Addendum #3

Re: Beaufort County Animal Shelter and Hilton Head Humane Association Animal Services Complex
Beaufort County, SC
10 Pritcher Point Road, Okatie, SC 29909
Bid Number: #041817E

This Addendum forms a part of the Contract Documents and modifies the original drawings and specifications dated 03/02/2017. Contractor shall be responsible to review changes to all portions of the work as changes of one portion may affect the work of another. Contractor shall indicate receipt of this addendum on the bid form.

3 COVERED STORAGE SECTION
SCALE: 1/4" = 1'-0"

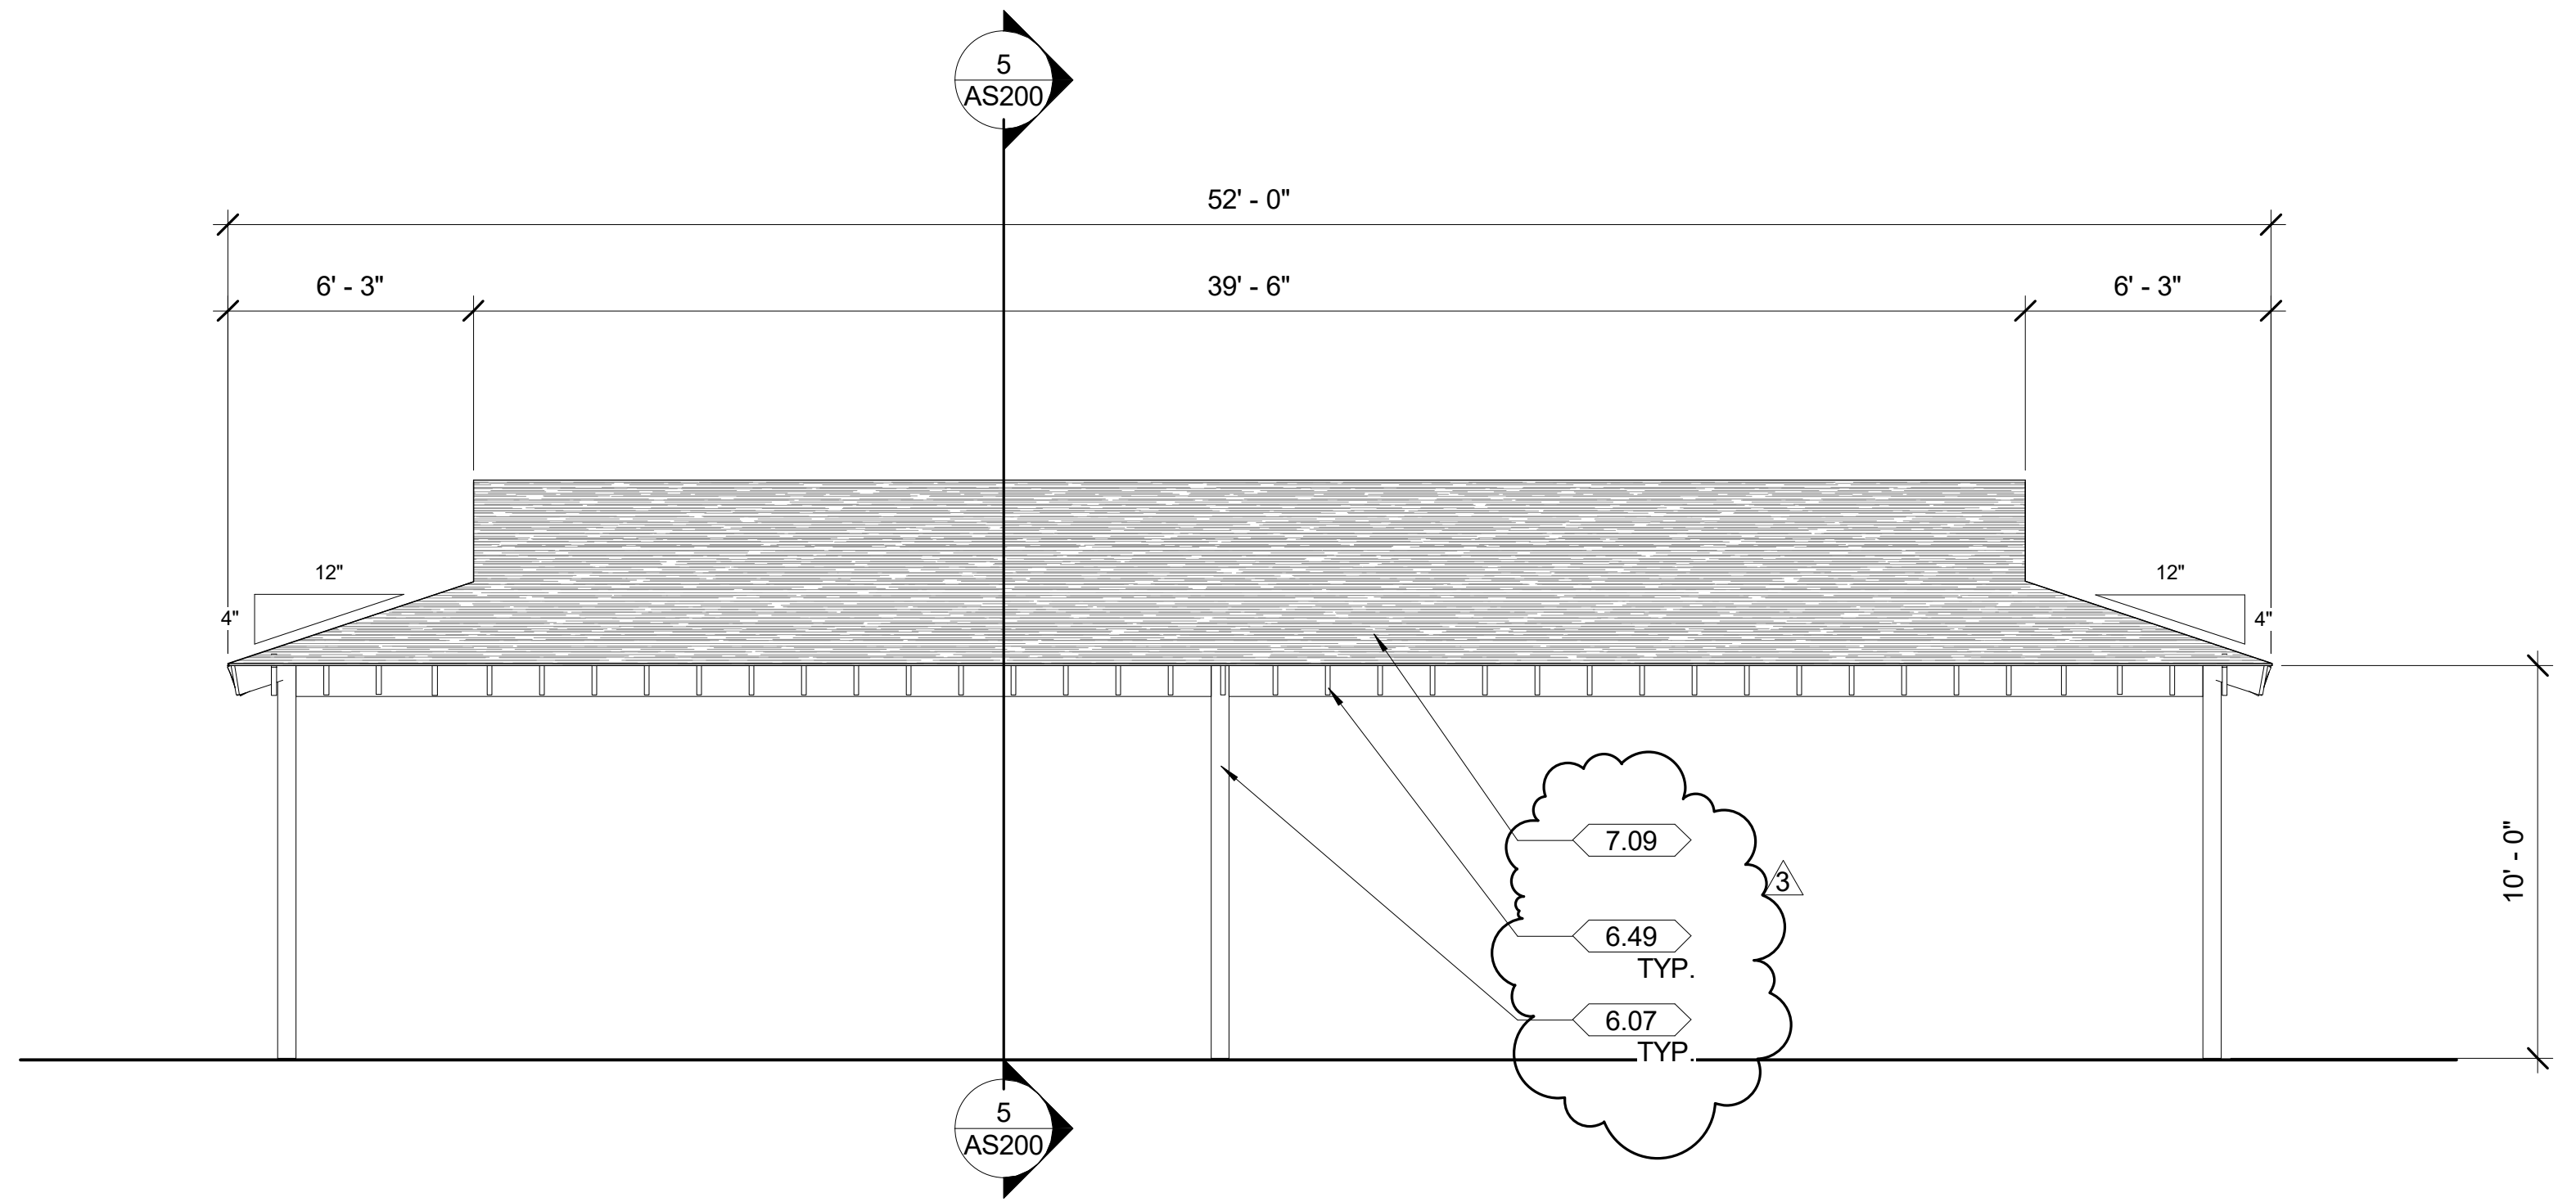
1. Revise Keynotes 6.34 and 6.41 to be Keynote 6.49. Keynote description as shown on attached Sheet.
2. Revise Keynote 6.07 to read as shown on attached Sheet.
3. Refer to attached Sheet.

20 ALUM SILL DETAIL
SCALE: 3" = 1'-0"

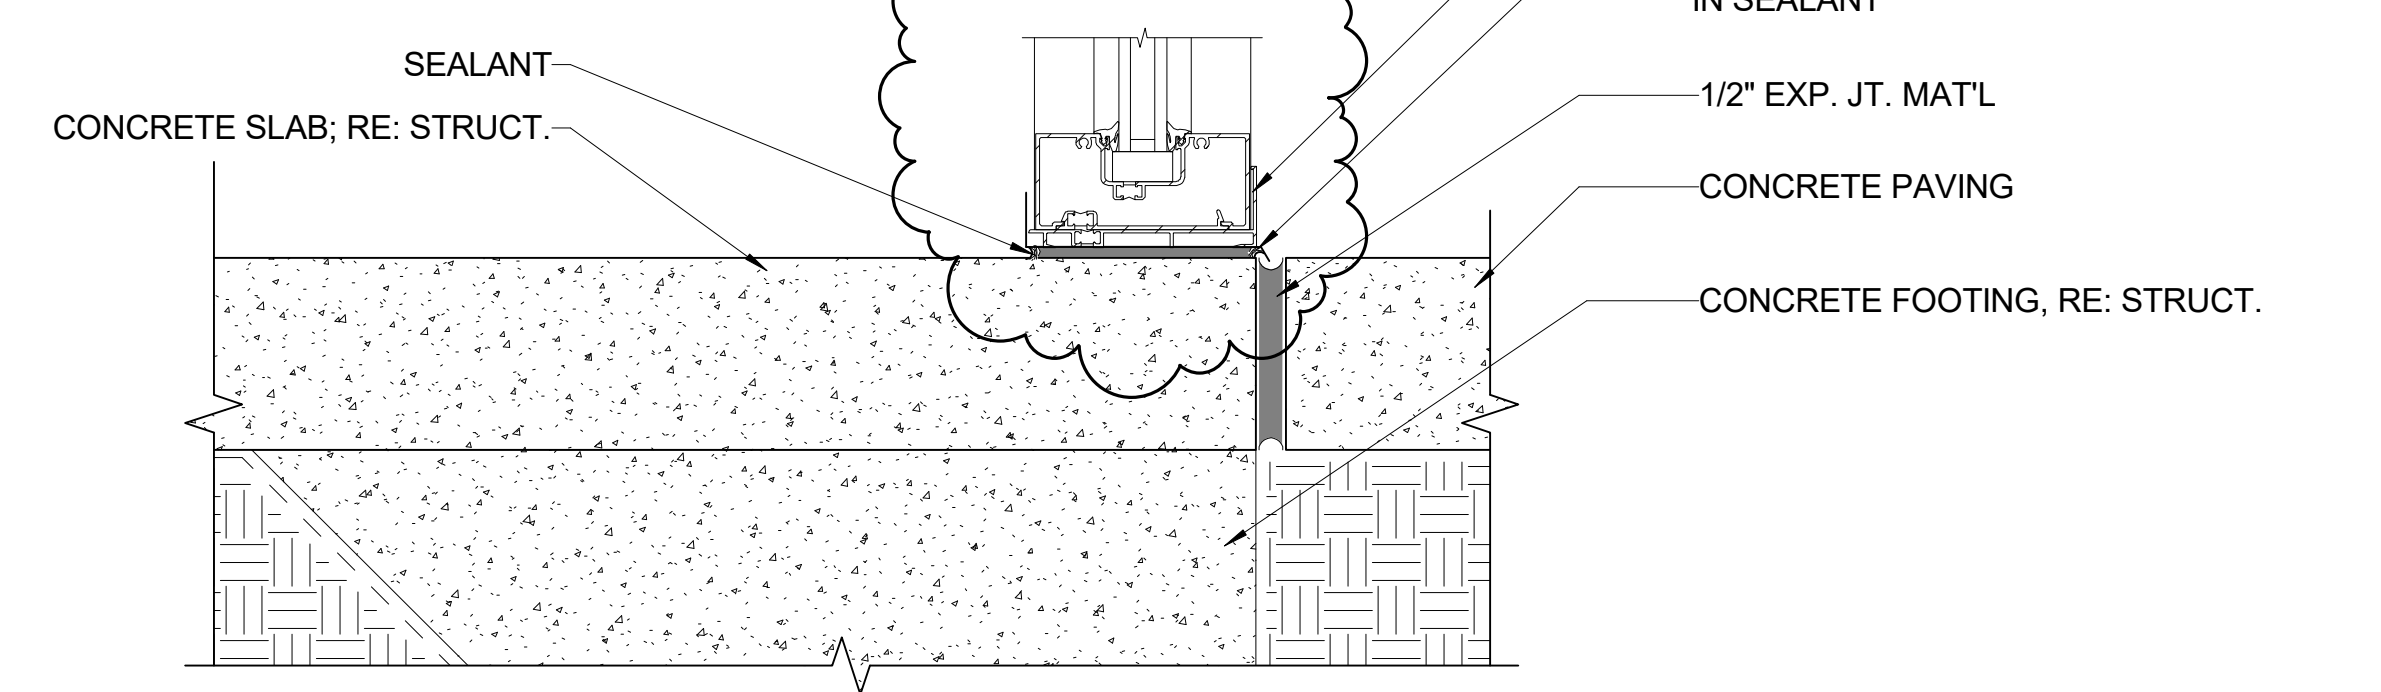
1. In Details 20 and 26, revise sill frame to be 2 ½” in height.
2. Refer to attached Sheet.
